Indianapolis Power and Light Company -- Feedback Response Table

**IPL's Response to Stakeholder Questions and
Comments - IRP Public Advisory Meeting #1**

Newly Created Energy Pie Charts

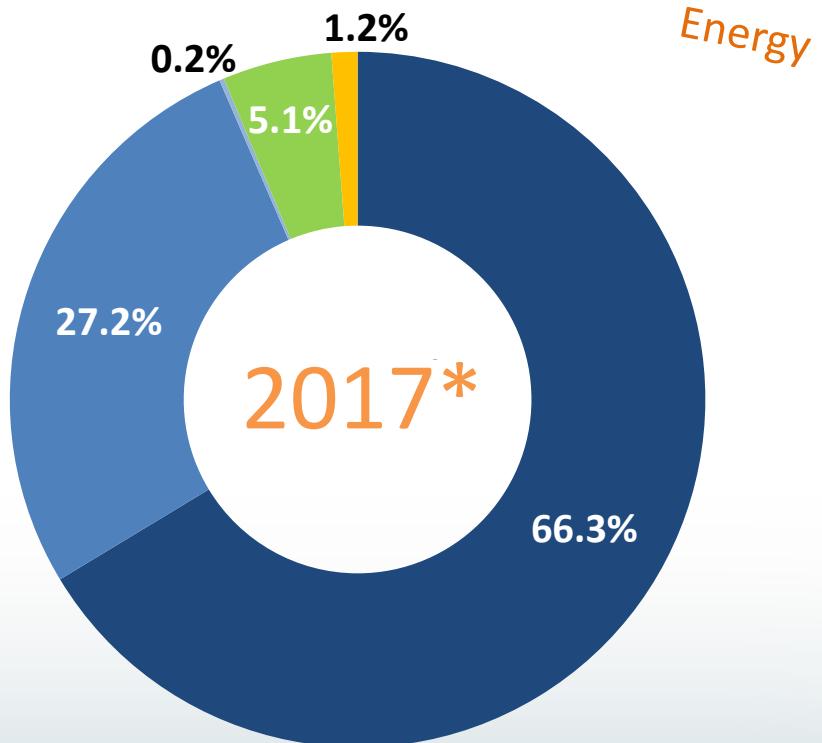
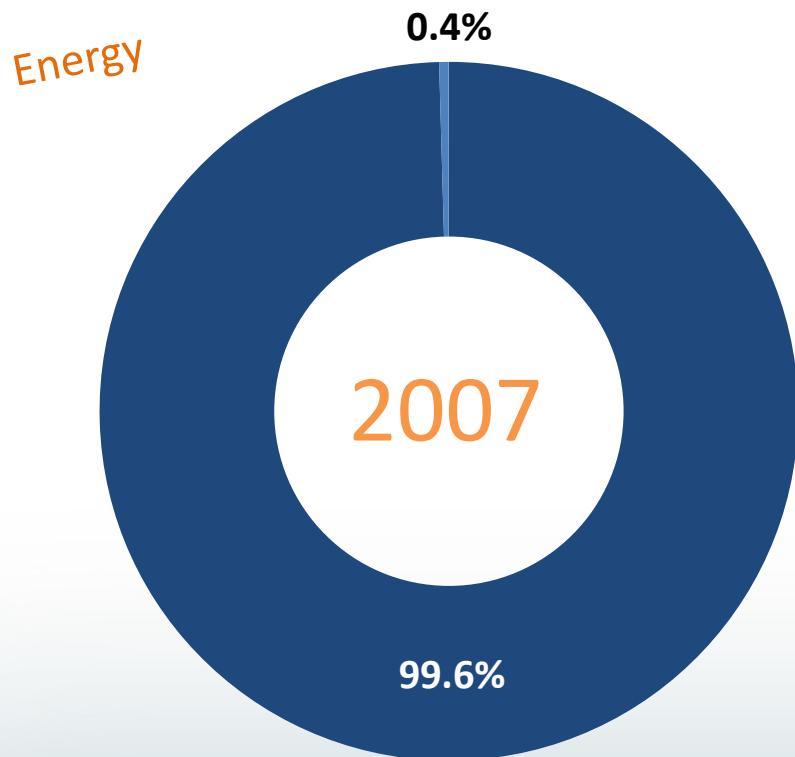
Generation	
Stakeholder Question or Comment	IPL's Response
1 Capacity prices have not been mentioned. I want to know how much excess capacity the Company is building and able to sell over the 20-year period.	Capacity in excess of minimum reserve margin requirements will be available upon completion of modeling runs. This information should be available at the July 18th meeting.
2 Off-system sales from excess generation available have also not been mentioned. Does the least cost plan assume that off-system sales revenues are passed on to ratepayers and does this comport with how they're currently handled.	The PVRR of the least cost plan is reduced by the amount of revenue, if any, associated with wholesale sales. This is consistent with the regulatory treatment IPL has received in its past rate cases.
3 Can you provide a pie chart showing actual generation versus projected (i.e. energy versus capacity)?	See Appendix Slide 3 for the energy pie chart. It should be noted that these percentages can vary significantly with changes in fuel costs and market prices. The capacity pie chart was provided as Slide 61 in the IRP Public Advisory Meeting #1 presentation.

It should be noted that these percentages can vary significantly based on unpredictable fuel costs and market prices.

Newly Created Energy Pie Charts With DSM

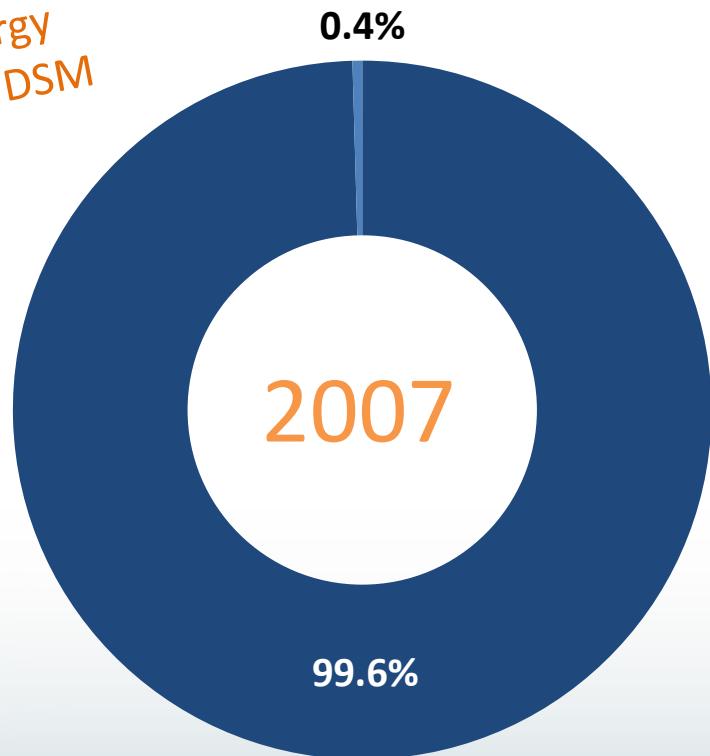
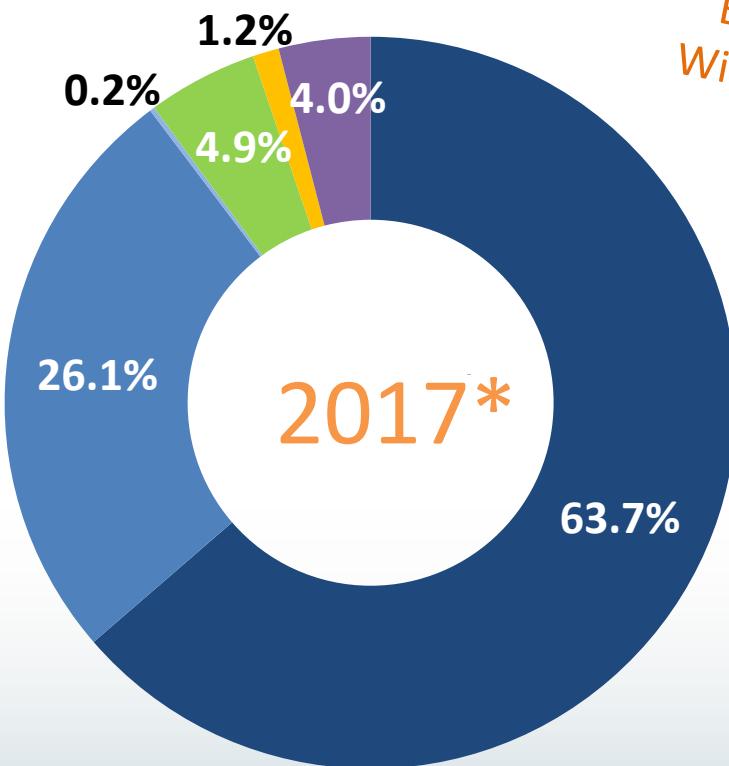
12	Pg 61 of presentation: Please provide charts that incorporate energy efficiency as a resource in 2017 and 2007.	See Appendix Slide 9 for the energy pie chart with DSM. It should be noted that the percentages can vary significantly with changes in fuel costs and market prices.	12

Energy
With DSM

Energy
With DSM

It should be noted that these percentages can vary significantly based on unpredictable fuel costs and market prices.

Regarding Slide 84 in the IRP Public Advisory Meeting #1 Presentation

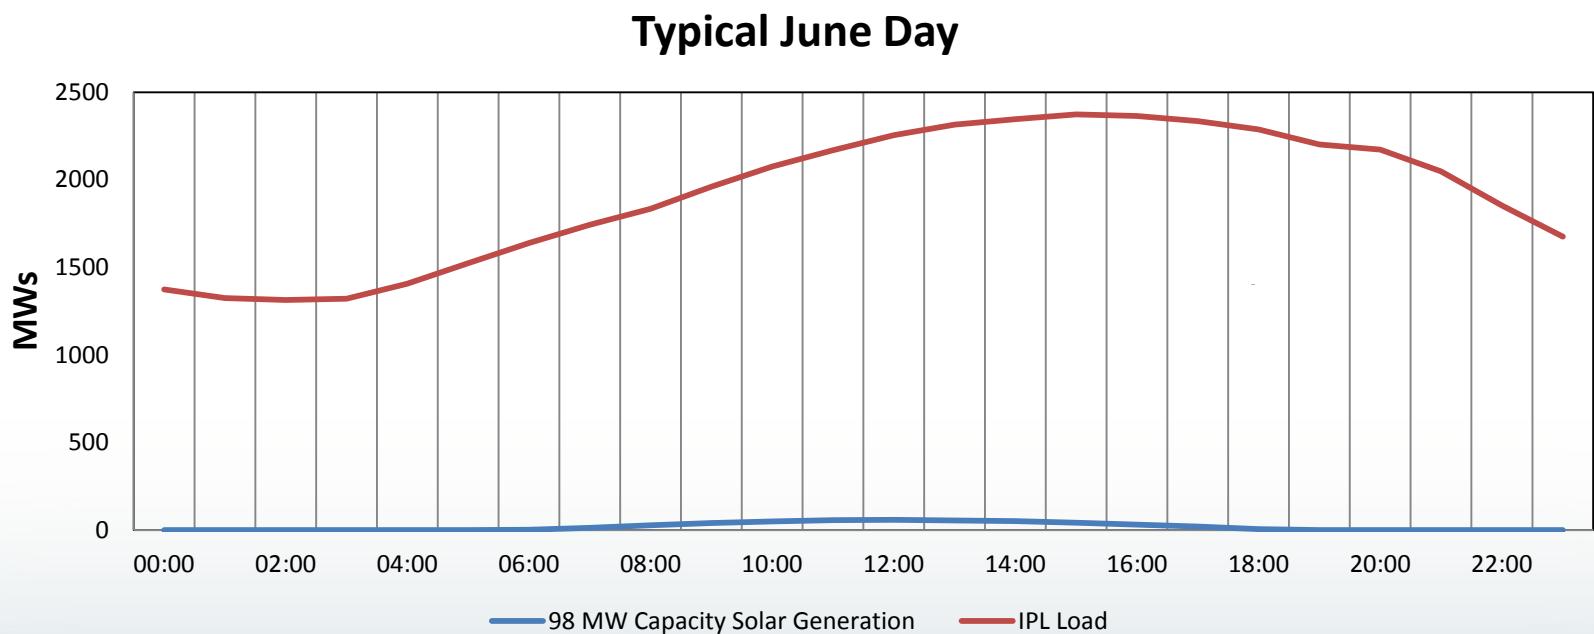
29	Pg 84 of presentation: The graph on page 84 is misleading because the gray block showing "summer peak hours" does not show energy demand throughout that entire June day, nor does it show how the peak rises and falls during the 3 p.m. – 7 p.m. period. Please provide a new graph overlaying solar generation with average June day demand.	See Appendix Slide 10 for the new graph overlaying solar generation with average June day demand.	29
30	Pg 84 of presentation: Mr. Haselden indicated that solar renewable energy credits are sold separately, mostly to Ohio. If the renewable energy credits are sold so that someone else is claiming the energy as renewable, IPL should not attribute words like renewable, solar or wind to this energy, as required by law. We would like IPL to keep RECs in Indiana.	IPL is very careful to follow the Federal Trade Commission's Green Guides and frequently consults with the Center for Renewable Solutions when there is a question on this topic. At present there is no market for RECs in Indiana other than an occasional sale for green power programs. Absent a mandate, other stakeholders want the RECs sold since the Fuel Adjustment mechanism is credited with revenue from those sales. Sales to entities in other states is the only significant current market opportunity. http://www.ftc.gov/opa/2012/10/greenguides.shtm	30

**New graph overlaying solar generation
with average June day demand.**
